SECTION 96 SUBMISSION

DEE WHY RSL CLUB - 932 PITTWATER ROAD  
STAGE 5 CLUB EXTENSION

4 5-DA-SHADOW DIAGRAM - 9AM 21JUNE  
Scale: 1 : 1000

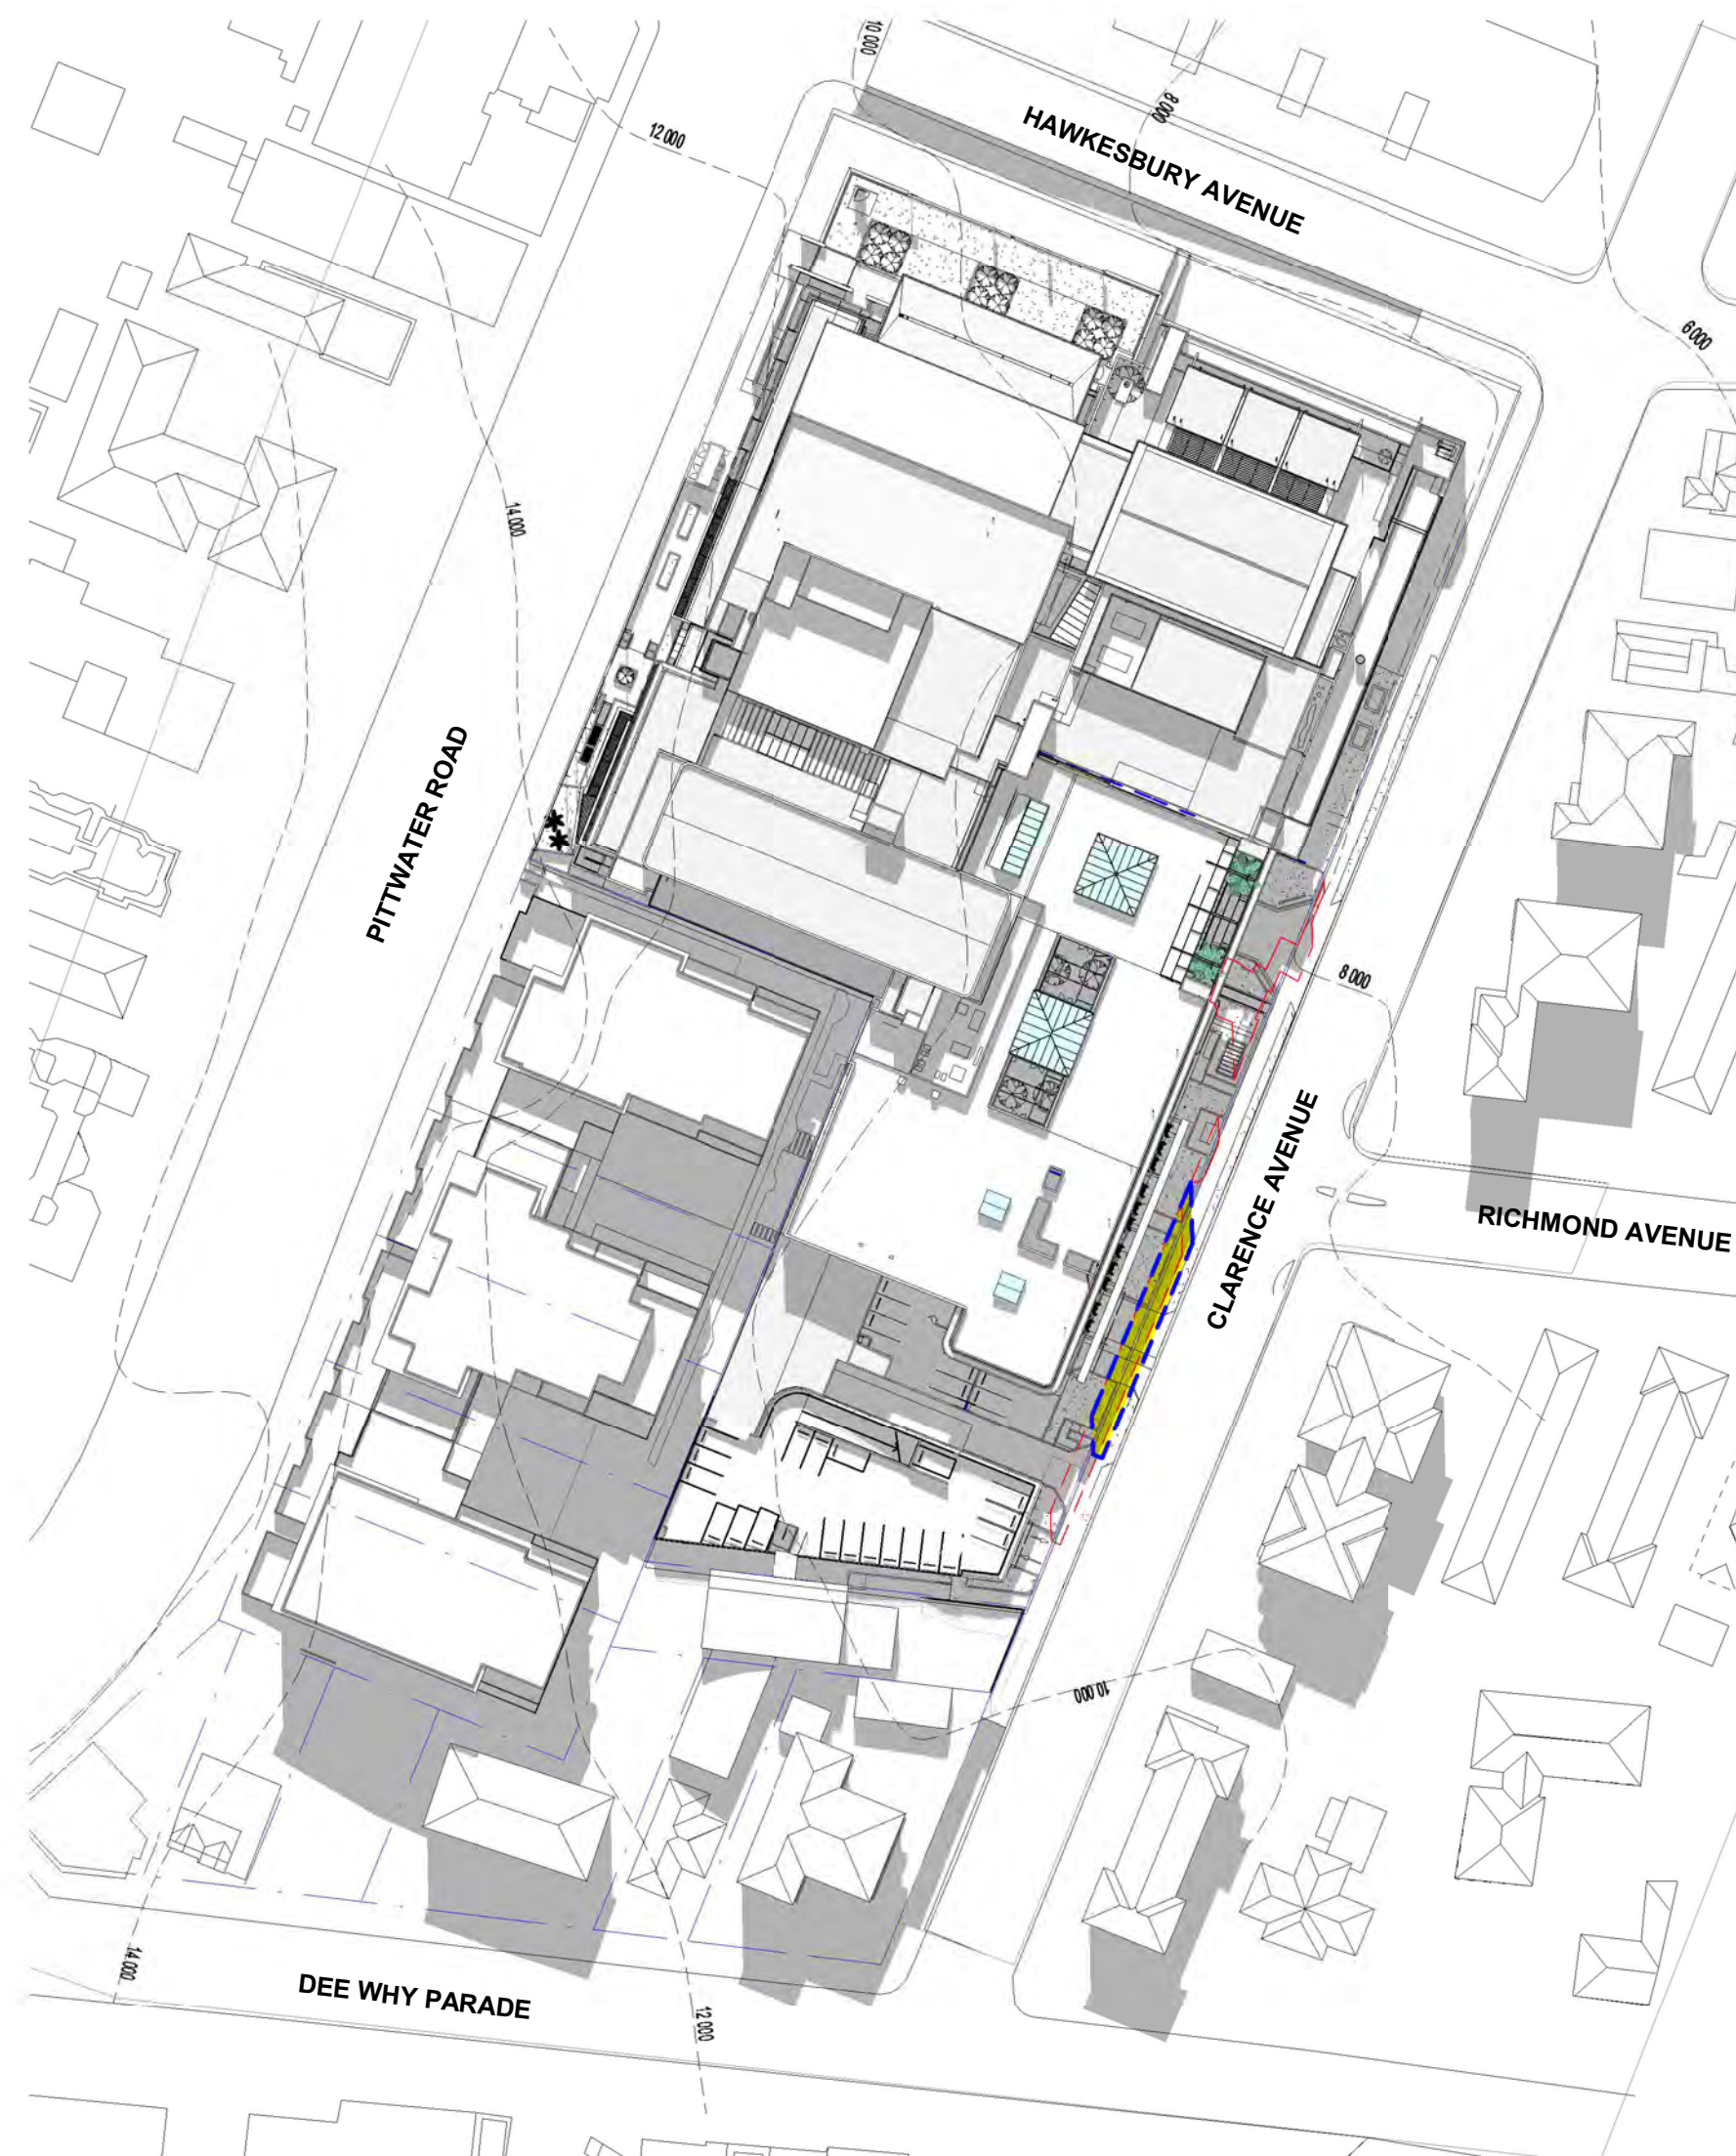
- SHADOW CAST BASED ON SECTION 96 MODIFICATIONS, REDUCED IMPACT
- SHADOW CAST ONTO SURROUNDING BY PROPOSED DEVELOPMENT AS PER ORIGINAL DA 2017/0244

CAR PARK LEVEL 1 (ENTRY LEVEL)  
EXISTING AND DEMOLITION PLAN

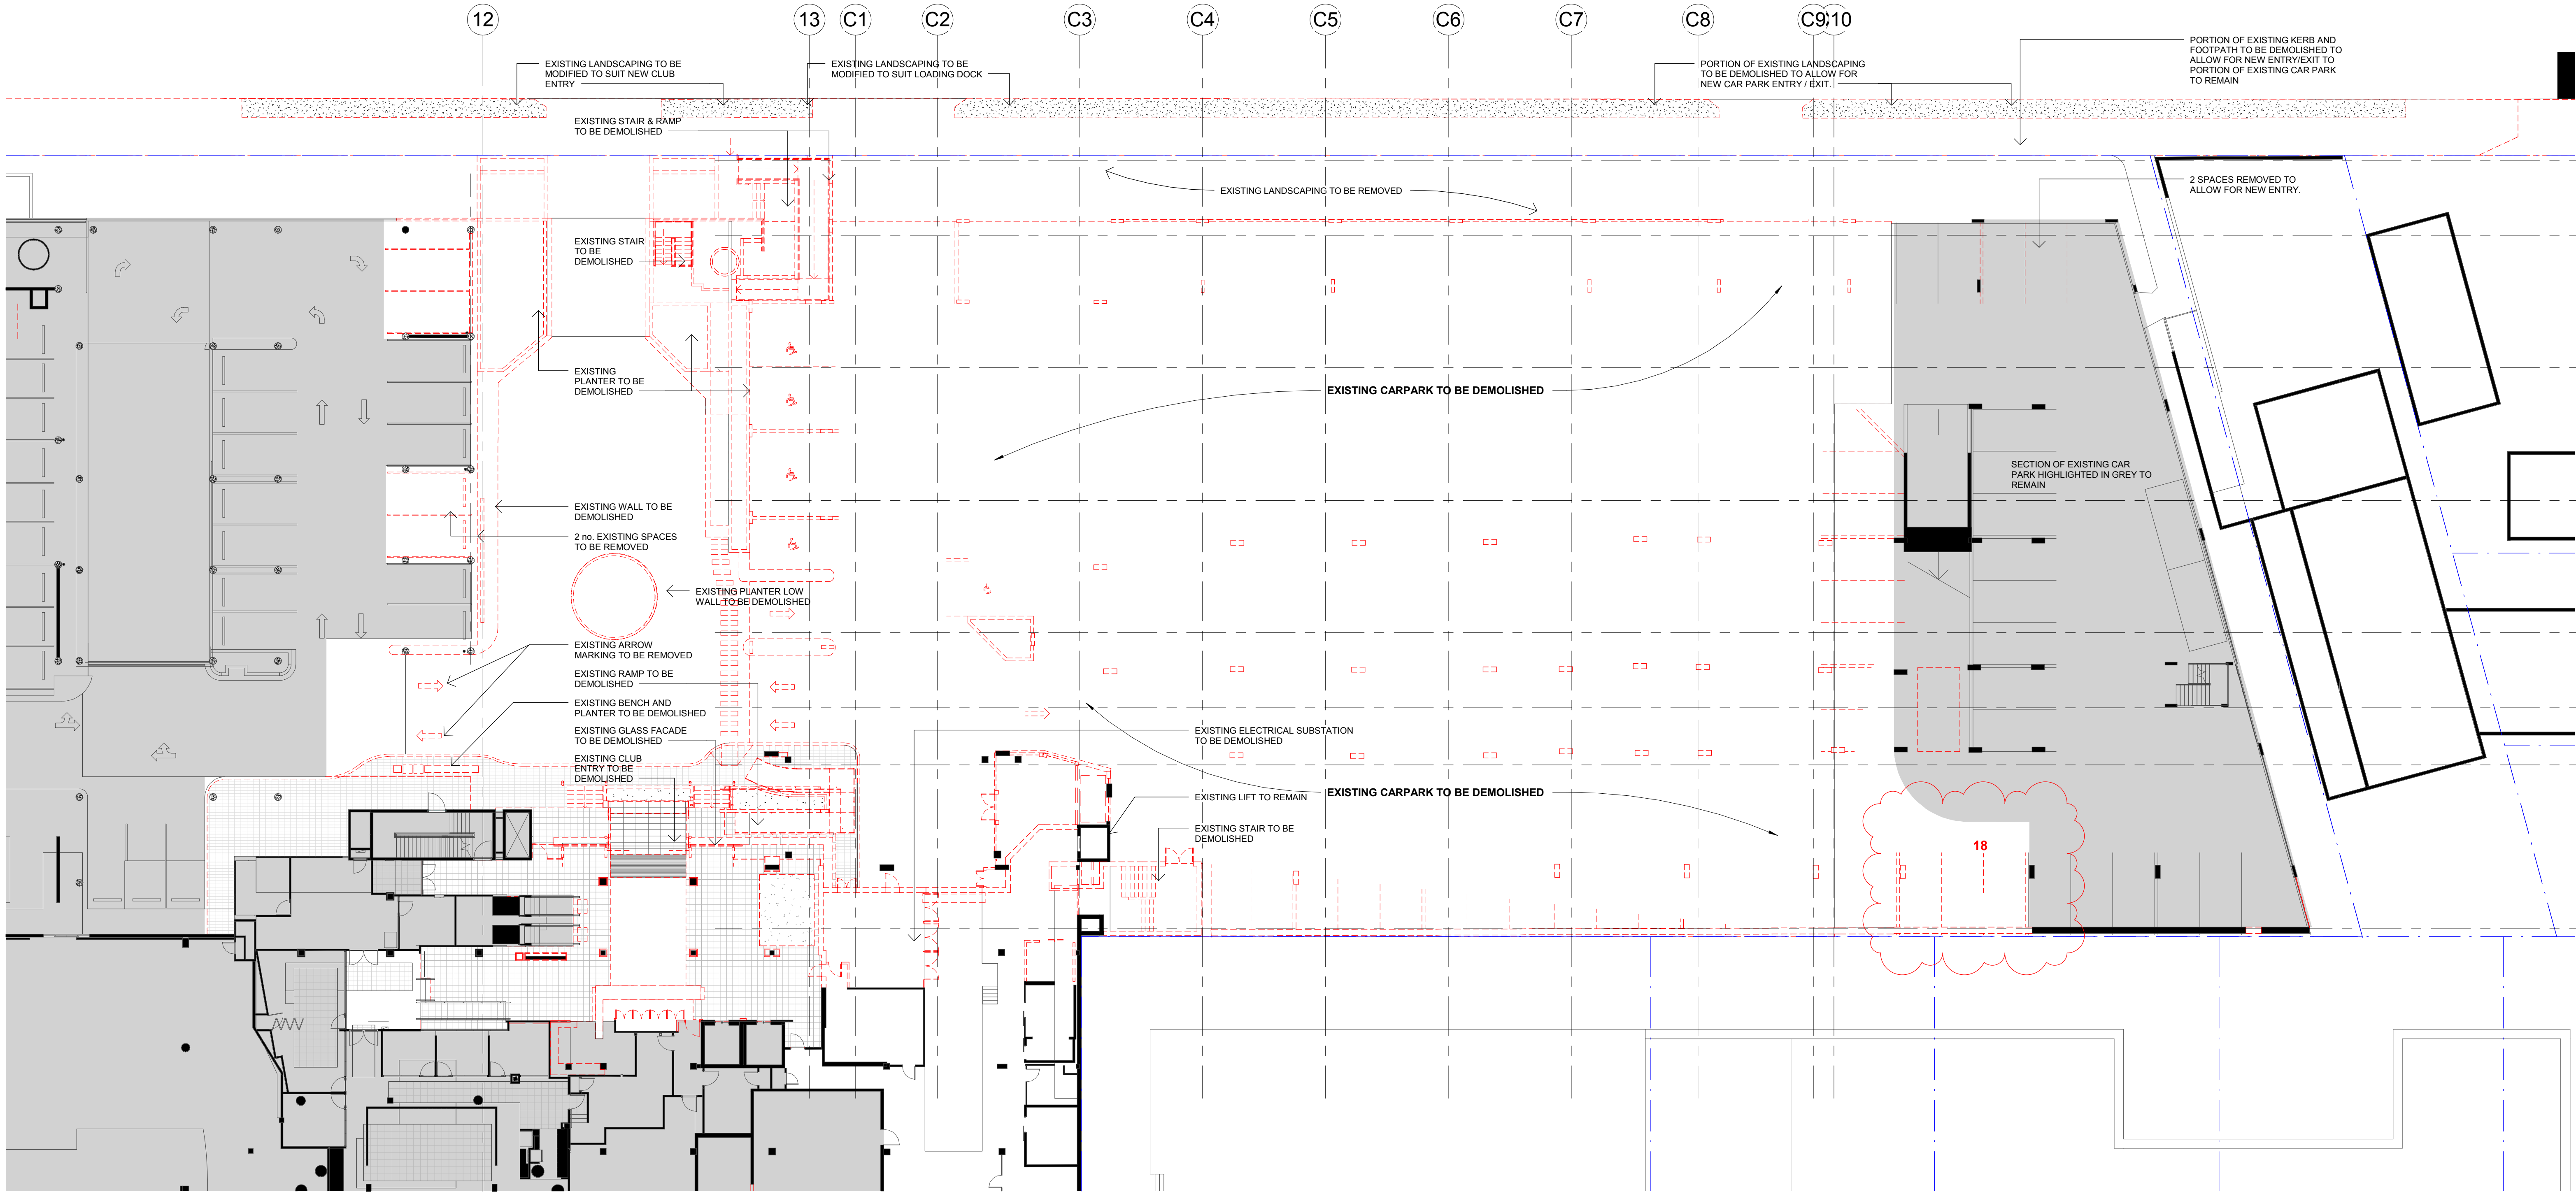
1. RELOCATED OPEN PLANTROOM AT THE ROOF LEVEL
2. MODIFIED ROOF OPENING ABOVE MAIN ENTRANCE
3. MODIFIED CENTRAL SKYLIGHT (REDUCED HEIGHT, MODIFIED PITCH)
4. MODIFIED COURTYARD: TWO OPEN COURTYARDS AND ONE SKYLIGHT COVERED AREA INSTEAD OF ONE LARGE GLASS ROOF. REDUCED HEIGHT AND PITCH

5. MODIFIED SMOKING TERRACE: ROOF OPENING, SIZE AND PLANTED AREA. AREA REDUCED BY 21m<sup>2</sup>
6. REDUCED NUMBER OF ROOF SKYLIGHTS ABOVE ASIAN RESTAURANT: 2 INSTEAD OF 6 TO SUIT THE NEW INTERNAL LAYOUT

7. MODIFIED EXIT STAIR: POSITION, CONFIGURATION, METAL ROOF NO LONGER REQUIRED
8. CONCRETE ROOF INSTEAD OF METAL DECK ROOF FOR THE MAJORITY OF THE BUILDING EXTENSION

9. NO SLAB ABOVE THE EXPOSED CAR PARK LEVEL 2 IN THE SOUTH AREA
10. NEW ACOUSTIC METAL ROOF ABOVE REVISED LOADING DOCK
11. MODIFIED FACADE APPEARANCE DUE TO CHANGES IN THE CAR PARK LEVELS, LOADING DOCK AND EGRESS STAIRS

12. REMOVED LOUVRES ON THE BACK FACADE (WESTERN FACADE) DUE TO MECHANICAL RISER NO LONGER REQUIRED / REVISED LOCATION FOR EGRESS DOORS
13. 2m WIDE INTERNAL EGRESS STAIR MODIFIED INTO TWO 1m WIDE EXTERNAL STAIRS WITH DECORATIVE BALUSTRADES

14. EXTENT OF LEVEL 2 (MAIN TRADING LEVEL) REDUCED BY 8326mm FROM THE SOUTHERN BOUNDARY AND INCREASED BY 1100mm TO THE EASTERN BOUNDARY
15. MODIFIED FACADE CURTAIN WALL MULLION BLADES

- ground/landscape/floor plate
18. REVISED LOADING DOCK ENTRANCE AND LOCATION/ ENLARGED DEMOLISHED AREA IN THE EXISTING RETAINED SOUTHERN CAR PARK
  19. NEW / MODIFIED EGRESS PATHS FROM EXISTING CARPARK LEVEL -1, NEW CARPARK LEVEL 1.

20. RELOCATED ELECTRICAL SUBSTATION / LANDSCAPED AREA MOVED TO SUIT
  21. MEDIAN STRIP ADDED AT ENTRY TO PROVIDE PLACE OF REFUGE AND ENSURE WIDTH OF ENTRY/ EXIT IS LESS THAN 8M AS PER DA CONDITION 23

24. BASEMENT CAR PARK LEVEL -5 ADDED
  25. CAR PARK ENTRY / EXIT MOVED TOWARD NORTH BY 3044mm
  26. PLANTER MODIFIED ON THE BACK (WESTERN) FACADE DUE TO REDUCTION OF THE MAIN TRADING FLOOR SLAB

27. LOCATION OF AIR INTAKE MODIFIED
  28. EXTENT OF RESTAURANT REDUCED BY 136m<sup>2</sup>
  29. CLUB ENTRANCE ACCESSIBLE RAMPS MODIFIED
  30. ONE ADDITIONAL EXISTING CAR PARK SPACE TO BE REMOVED FROM EXISTING NORTHERN CAR PARK

31. SOLID MASONRY WALL ADDED BETWEEN EXISTING ZONE D CAR PARK AND LOADING DOCK ACCESS.

1 5B-AD-S96-CAR PARK LEVEL 2 EXISTING AND DEMOLITION PLAN  
Scale: 1:200

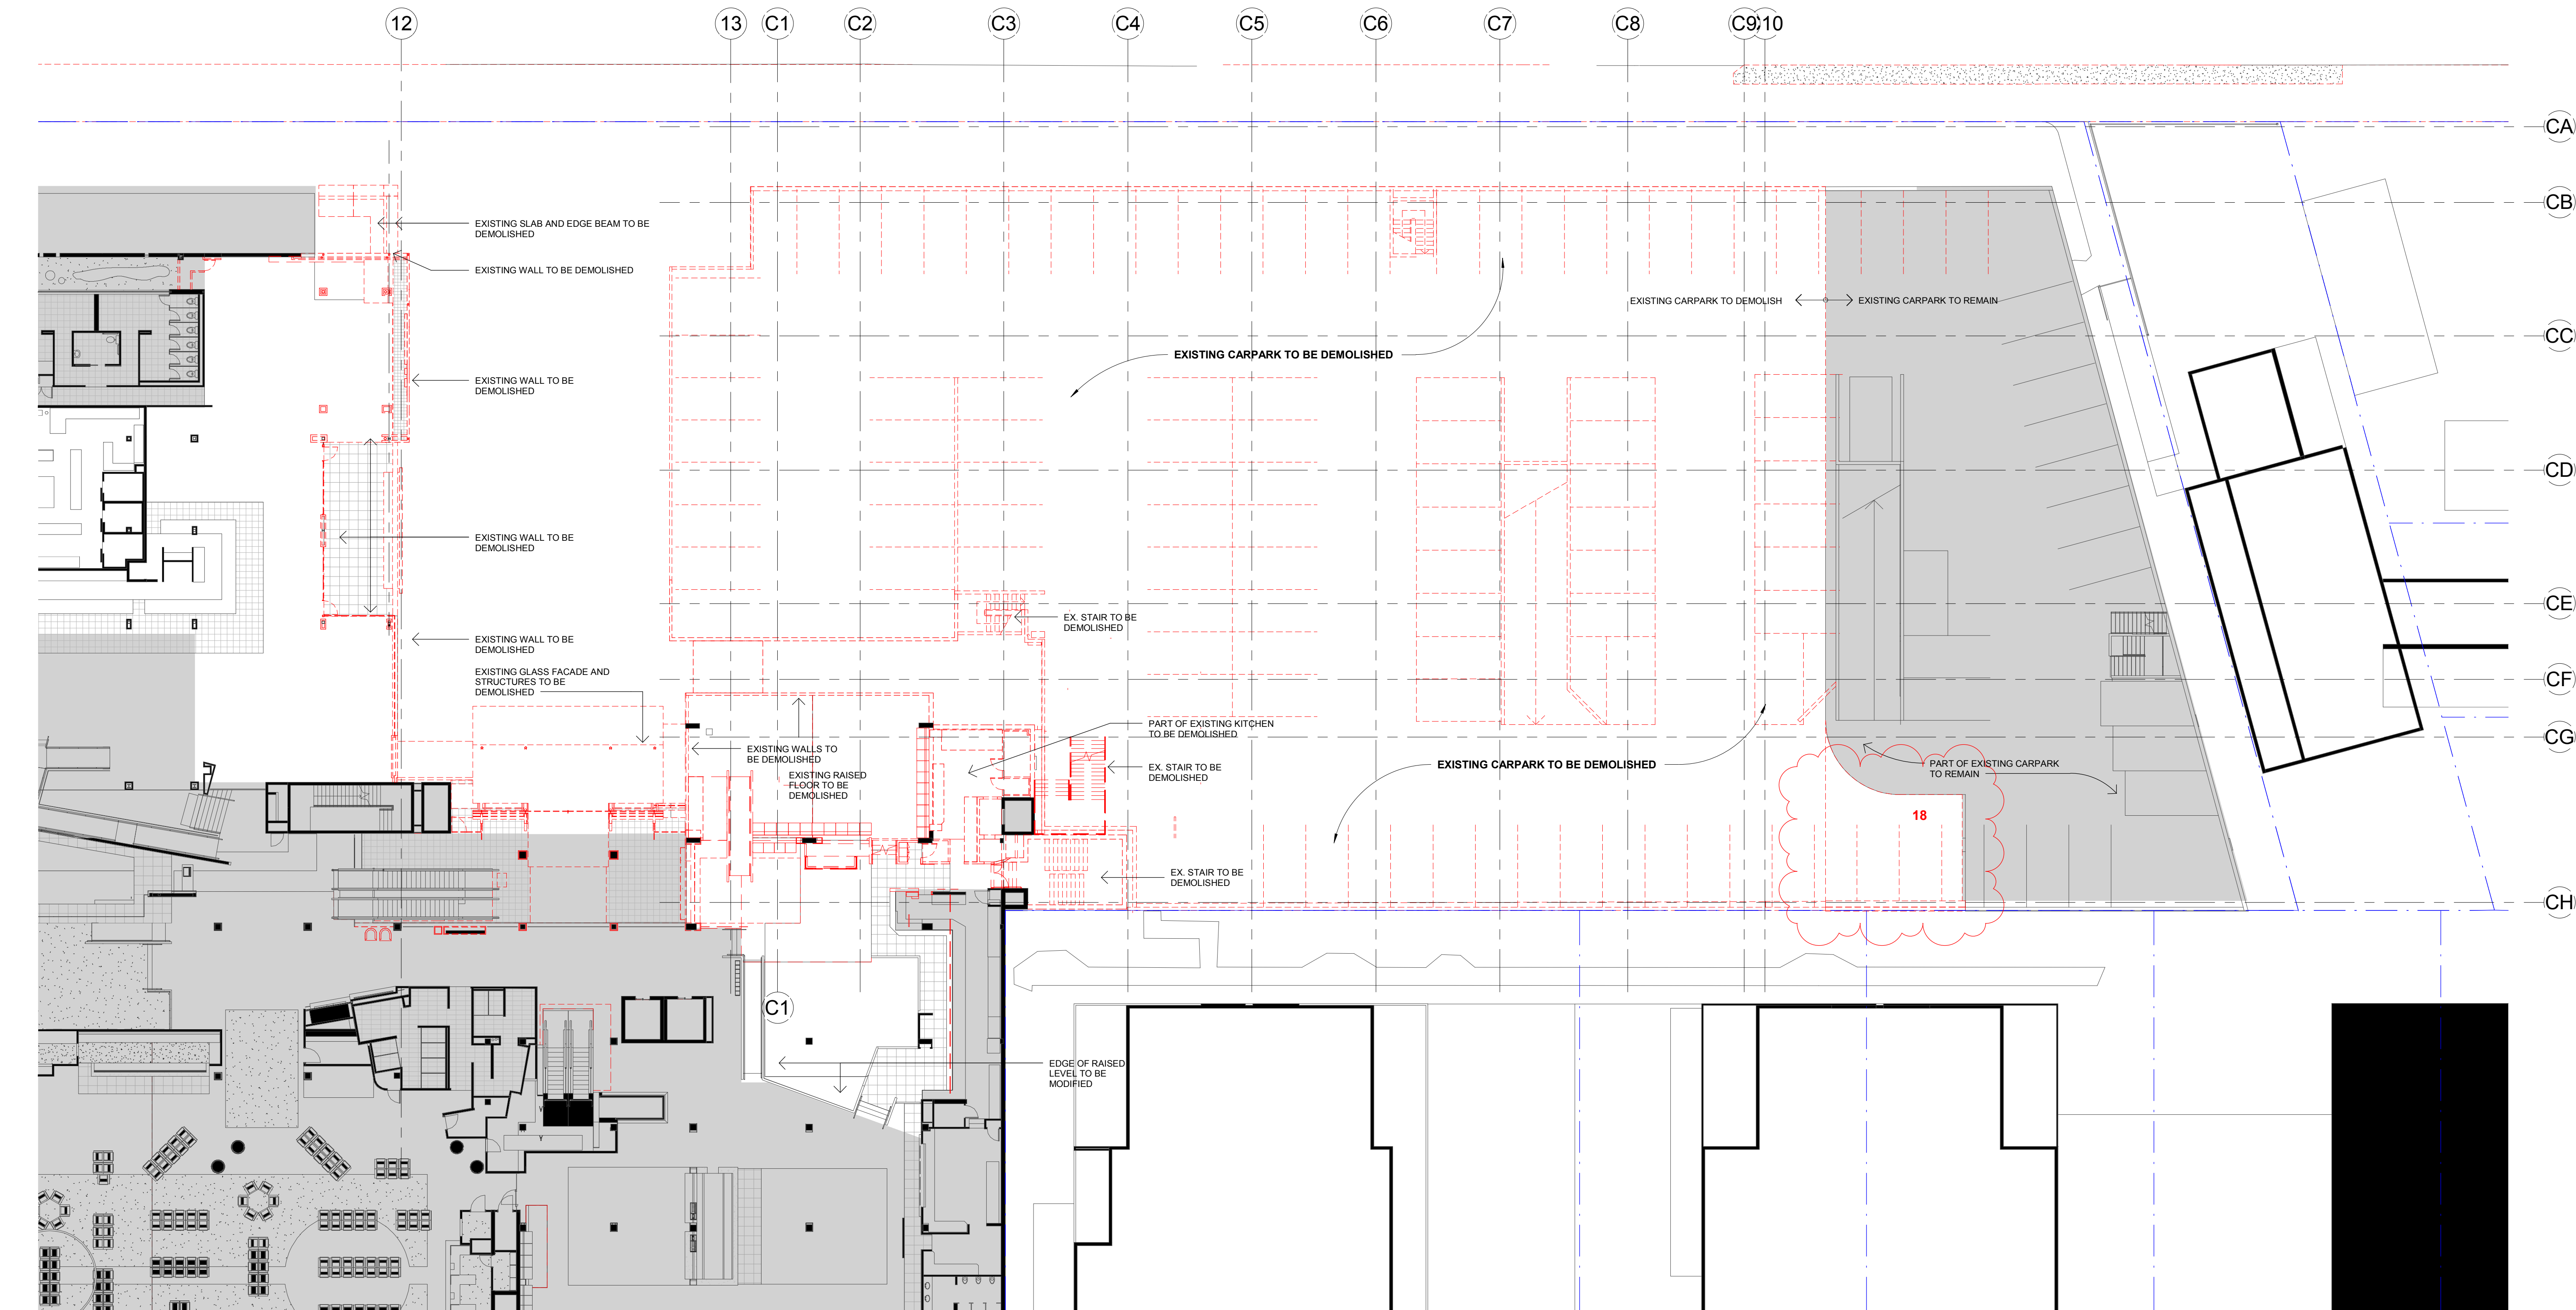
1. RELOCATED OPEN PLANTROOM AT THE ROOF LEVEL
2. MODIFIED ROOF OPENING ABOVE MAIN ENTRANCE
3. MODIFIED CENTRAL SKYLIGHT (REDUCED HEIGHT, MODIFIED PITCH)
4. MODIFIED COURTYARD: TWO OPEN COURTYARDS AND ONE SKYLIGHT COVERED AREA INSTEAD OF ONE LARGE GLASS ROOF: REDUCED HEIGHT AND PITCH
5. MODIFIED SMOKING TERRACE: ROOF OPENING, SIZE AND PLANTED AREA. AREA REDUCED BY 21m<sup>2</sup>
6. REDUCED NUMBER OF ROOF SKYLIGHTS ABOVE ASIAN RESTAURANT: 2 INSTEAD OF 6 TO SUIT THE NEW INTERNAL LAYOUT
7. MODIFIED EXIT STAIR: POSITION, CONFIGURATION, METAL ROOF NO LONGER REQUIRED
8. CONCRETE ROOF INSTEAD OF METAL DECK ROOF FOR THE MAJORITY OF THE BUILDING EXTENSION
9. NO SLAB ABOVE THE EXPOSED CAR PARK LEVEL 2 IN THE SOUTH AREA
10. NEW ACOUSTIC METAL ROOF ABOVE REVISED LOADING DOCK

11. MODIFIED FACADE APPEARANCE DUE TO CHANGES IN THE CAR PARK LEVELS, LOADING DOCK AND EGRESS STAIRS
12. REMOVED LOUVRES ON THE BACK FACADE (WESTERN FACADE) DUE TO MECHANICAL RISER NO LONGER REQUIRED / REVISED LOCATION FOR EGRESS DOORS
13. 2m WIDE INTERNAL EGRESS STAIR MODIFIED INTO TWO 1m WIDE EXTERNAL STAIRS WITH DECORATIVE BALUSTRADES
14. EXTENT OF LEVEL 2 (MAIN TRADING LEVEL) REDUCED BY 8328mm FROM THE SOUTHERN BOUNDARY AND INCREASED BY 1100mm TO THE EASTERN BOUNDARY
15. MODIFIED FACADE CURTAIN WALL MULLION BLADES REDUCED BY 147mm
16. CONCRETE BLADE WALL REDUCED BY 147mm IN HEIGHT AND 6.2m IN LENGTH
17. VERTICAL FINIS REMOVED FROM BACK WALL (WESTERN FACADE)

18. REVISED LOADING DOCK ENTRANCE AND LOCATION/ENLARGED DEMOLISHED AREA IN THE EXISTING RETAINED SOUTHERN CAR PARK
19. NEW / MODIFIED EGRESS PATHS FROM EXISTING CARPARK LEVEL -1. NEW CARPARK LEVEL 1.

20. RELOCATED ELECTRICAL SUBSTATION / LANDSCAPED AREA MOVED TO SUIT
21. MEDIAN STRIP ADDED AT ENTRY TO PROVIDE PLACE OF REFUGE AND ENSURE WIDTH OF ENTRY/ EXIT IS LESS THAN 8M AS PER DA CONDITION 23

24. BASEMENT CAR PARK LEVEL -5 ADDED.
25. CAR PARK ENTRY / EXIT MOVED TOWARD NORTH BY 3044mm
26. PLANTER MODIFIED ON THE BACK (WESTERN) FACADE DUE TO REDUCTION OF THE MAIN TRADING FLOOR SLAB

27. LOCATION OF AIR INTAKE MODIFIED
28. EXTENT OF RESTAURANT REDUCED BY 136m<sup>2</sup>
29. CLUB ENTRANCE ACCESSIBLE RAMPS MODIFIED
30. ONE ADDITIONAL EXISTING CAR PARK SPACE TO BE REMOVED FROM EXISTING NORTHERN CAR PARK

31. SOLID MASONRY WALL ADDED BETWEEN EXISTING ZONE D CAR PARK AND LOADING DOCK ACCESS.
